## **Final Decision**

Type II Staff Report: Street Adjustment

**File number(s):** SA 2023-06

**Project name:** Flores Residence / 1600 Tomlin Avenue

Exhibit SA3: WDO Figure 3.01G

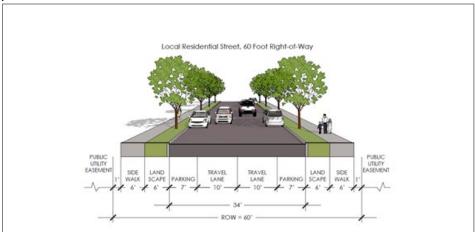
a. Tomlin: Construct a half-street conforming with WDO 3.01.03C.2, Figure 3.01G, & 3.06.03A, with allowance to pay fee or fees in-lieu as 3.02.03C.2 and 4.02.12 allow and per Attachment 201.

- (1): About street tree root barriers, the contractor is to see and conform with <u>Public</u> Works Standard Drawing No. 1 "Street Tree Planting New Construction" or as amended.
- (2): About the upgraded driveway approach, apron, curb cut, or ramp, the contractor is to see within the <a href="Public Works Standard Drawing 4150 series">Public Works Standard Drawing 4150 series</a> Nos. 4150-1 "Driveway Approach" & 4150-4 "Property Line Sidewalk at Driveway" or as amended.
- b. Christiansen:
  - (1) Sidewalk: Instead of per WDO 3.01.03C.2c, applicant's choice of either sidewalk minimum width 6 ft, sited and constructed as per civil plans approved by Public Works, or payment of sidewalk fee in-lieu per Attachment 201.
  - (2) Street trees: Per WDO 3.01.03C.2d, including minimum 6 trees. If opting for fee in-lieu, the amount is per Attachment 201.

Figure 3.01G – Local Residential Street with Parking Both Sides, 60 Foot Right-of-Way

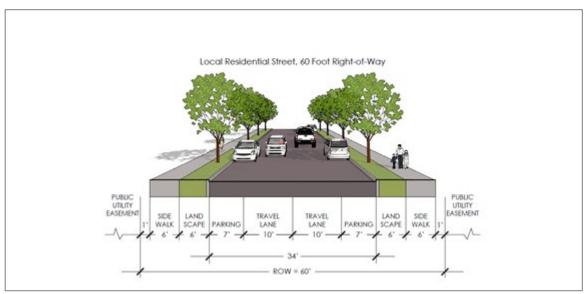
The applicant submitted a Street Adjustment request to not dedicate 5 ft of ROW or install a landscape strip as shown in Figure 3.01G – the standard cross-section for residential local streets per 3.01.04B.1. Staff determines that, with the recommended condition of approval to dedicate a wider streetside PUE, that the proposal can meet criteria as staff examines below under the Street Adjustment Provisions section.
